Access Compliance Report Public Rights-of-Way (Curb Ramps)

Main Street: SCOTCH_PINE_DR		Cross Street: BLUE_SPRUCE_DR		Location:	E
ADA ID: RPAT211101143234	Ramp Type: Type 4 - Parallel	Initial Pass/Fail: Fail	Overall Compliance: No	Severity Score:	16

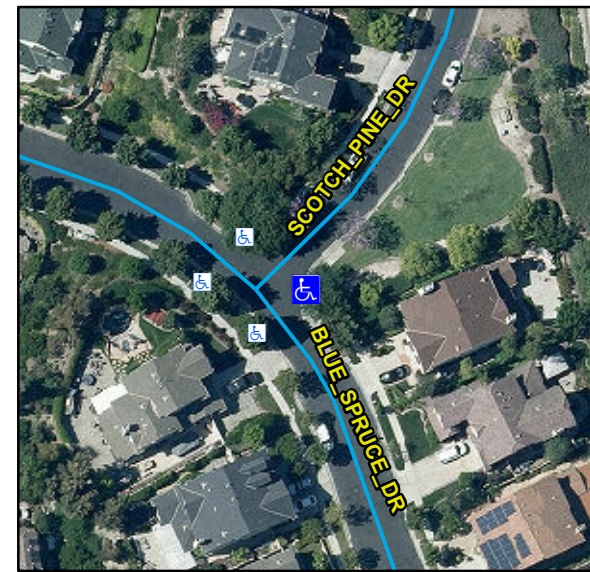
Compliance	Description	Data	Compliance	Description	Data
N/A	Ramp Length LT (in)	100	N/A	Ramp Length RT (in)	105
Yes	Ramp Width LT (in)	54	Yes	Ramp Width RT (in)	52
Yes	Ramp Run Slope LT (%)	3.6	No	Ramp Run Slope RT (%)	10.3
Yes	Ramp Cross Slope LT (%)	1.2	No	Ramp Cross Slope RT (%)	2.2
N/A	Landing Present	N/A	N/A	DWS Provided	N/A
N/A	Landing Length (in)	N/A	N/A	DWS Contrast	N/A
N/A	Landing Width (in)	N/A	N/A	DWS Length (in)	N/A
N/A	Landing Run Slope (%)	N/A	N/A	DWS Full Width	N/A
N/A	Landing Cross Slope (%)	N/A		DWS Offset Type	N/A
N/A	Landing Movement Obstructed?	N/A	N/A	DWS Offset Left (in)	N/A
	Landing Movement Type	N/A	N/A	DWS Offset Right (in)	N/A
N/A	Landing Shared	N/A			
N/A	Clear Space	Yes			
N/A	Clear Space To Crosswalk (in)	N/A			
N/A	Marked Crosswalk 1	No	N/A	Marked Crosswalk 2	No
	Crossing 1 Direction	NW		Crossing 2 Direction	SW
N/A	Marked Crosswalk 1 Width (in)	N/A		Marked Crosswalk 2 Width (in)	N/A

N/A	Ramp Inside Crosswalk 1	N/A	N/A	Ramp Inside Crosswalk 2	N/A
	Crossing 1 Slope (%)	5.8		Crossing 2 Slope (%)	1.7
	Crossing 1 Cross Slope (%)	1.4		Crossing 2 Cross Slope (%)	5.9
N/A	Gutter Ponding	N/A	N/A	Curb Slope	9.1
Yes	Gutter Lip Height (in)	0		Road Run Slope (%)	3.2
N/A	Gutter Run Slope (%)	N/A		Road Cross Slope (%)	1.3
N/A	Gutter Cross Slope (%)	N/A	No	Perpendicular Joint Present	No
Yes	Overall Surface Condition	Acceptable			
	Cross Gutter Present?	No		Spandrel Present?	No
	Replace Cross Gutter?	N/A		Replace Spandrel?	N/A

Remove & Replace Curb Ramp With Two New Directional Ramps or Equivalent.
